Permit No: 0606870

Site Address: 2960 SPOONWOOD WY SAC
Parcel No: RIVERDALE NORTH VILLAGE 1 LOT #1

Nature of Work: MP 1194 2 STORY 6 RM SFR

| REP_1194A | B04 | CAL HIP | 1 | 1 | Revision 23462 - Beazer - Lot 1001 |

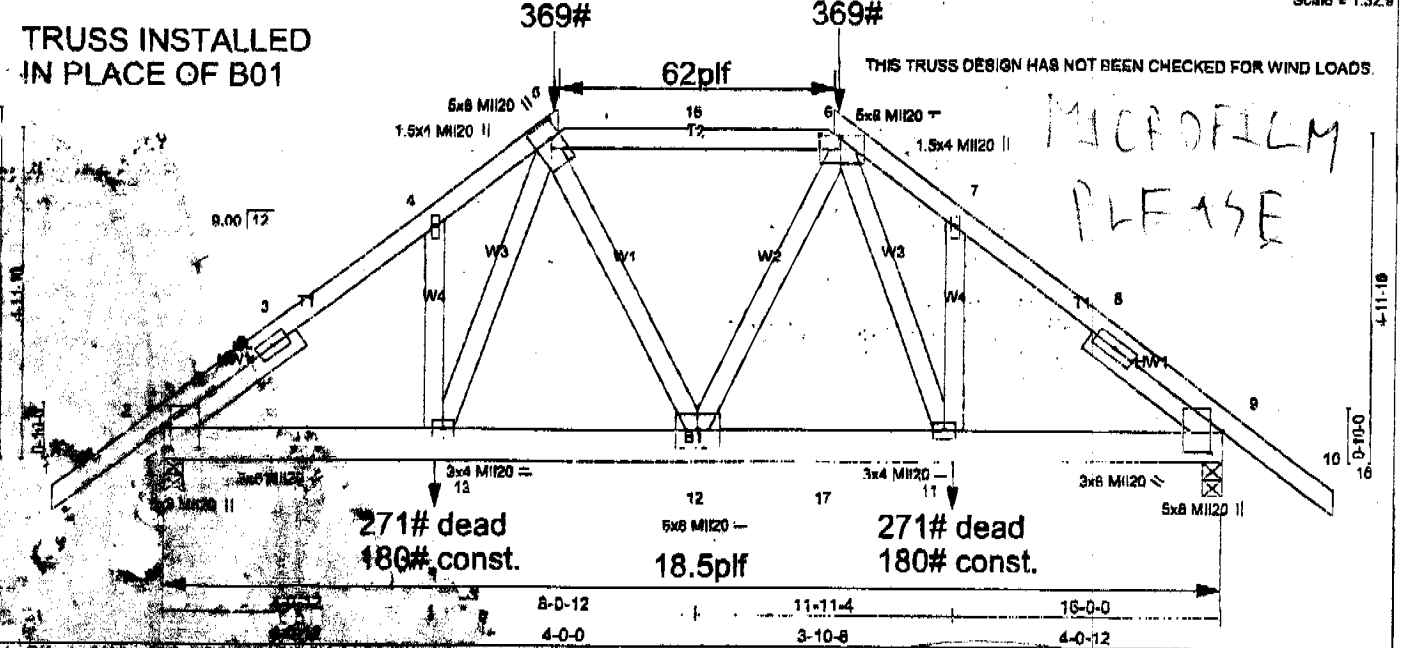
General Revision Notes:
 1) This revision is for installing this truss in place of B01.
 All other lumber and plates are intact and unaltered.
 2) Shore truss to original geometry prior to revision.
 3) No repair is needed.
 4) Mechanical, if in the way, is to be relocated to accommodate revision.
 This revision was designed using a description of existing conditions as provided by others.
 The truss designer performs no field inspection of trusses.

NEW CSI's AND DEFL.

NEW BRACING

NEW REACTIONS AND FORCES

NEW NOTES

Hanger(s) or other connection device(s) shall be designed and installed to support connections and loads) 389 lb down at 10-1-3, and 369 lb down at 5-10-13 on top chord, and 271 lb down at 11-11-3 and 351 lb down at 4-0-12 on bottom chord. The design/selection of such connection device(s) is the responsibility of the contractor.

| REP_1194A | B01 | CAI, HIP | 1 | 1 | Repair 23461 - Bonzer - Lot 1001 |

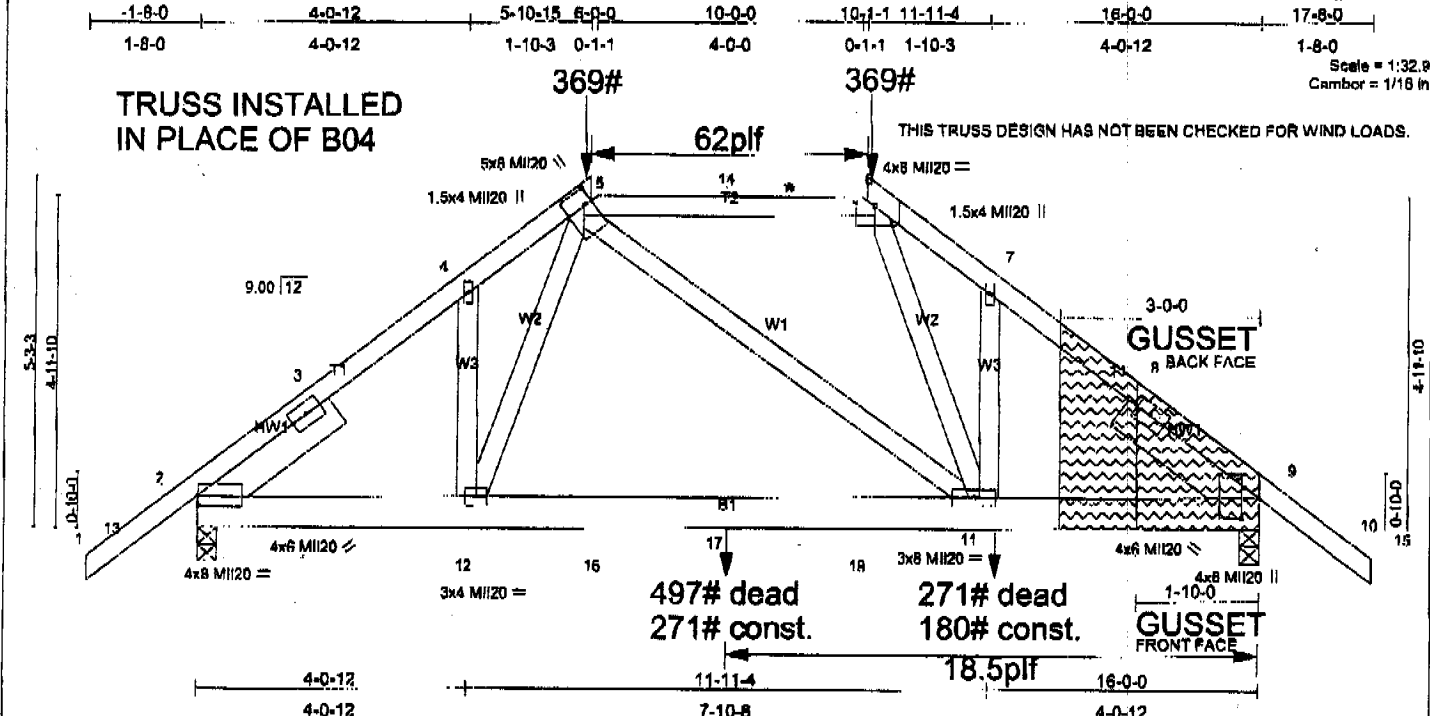
- This repair is for installing this truss in place of B04. All other lumber and plates are intact and undisturbed.
- Shore truss to original geometry prior to repair.
- Attach 23/32" OSB (48/24) or 1/2" plywood Str. 1 gussets nailed to EACH face of truss w/10d gun nails (0.131" dia. Ry 3" long) 1 row(s) @ 3" o.c. staggered. Nails to be placed with sufficient edge distances and end distances as to prevent splitting of wood members. Do not damage repair.
- Mechanical, if in the way, is to be relocated to accommodate repair. This repair was designed using a description of existing conditions as provided by others. The truss designer performs no field inspection of trusses.

NEW CSI's AND DEFL.

NEW BRACING

NEW REACTIONS AND FORCES

NEW NOTES

Hanger(s) or other connection device(s) shall be provided sufficient to support concentrated load(s) 369 lb down at 10-2-5, and 369 lb down at 5-10-13 on top chord, and 271 lb down at 11-11-4 on bottom chord. The design/selection of such connection device(s) is the responsibility of others.
